QUALITY ALERT!

11 – 33kV Cable Termination Quality Issues

Quality Alert REF No : 2018-006

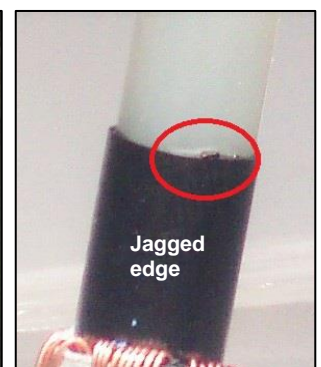
Submitted cable termination sheets and photographs have revealed several quality issues with installed terminations. The quality issues on these cable terminations based on the submitted photos included:

- Non-chamfered and jagged edge at the semi-conductive cut back.
- Copper screen wires not pressed into mastic which can allow moisture ingress over time.
- The top XLPE insulation was not beveled and rounded using correct tools. A knife was used leaving sharp edges.
- Inadequate application of sealing mastic between the cable lug and the XLPE.

1. The form attached in Appendix B of **TP.CL 01.02** is to be sent to tpcables@transpower.co.nz within **2 working days** of completing the work. TP.CL 01.02 is to be updated with this requirement.
2. There is work underway to improve the Training and Competency of those working on Transpower cables to improve the quality of this work, specify use of the correct tools and the QA process for completed work.
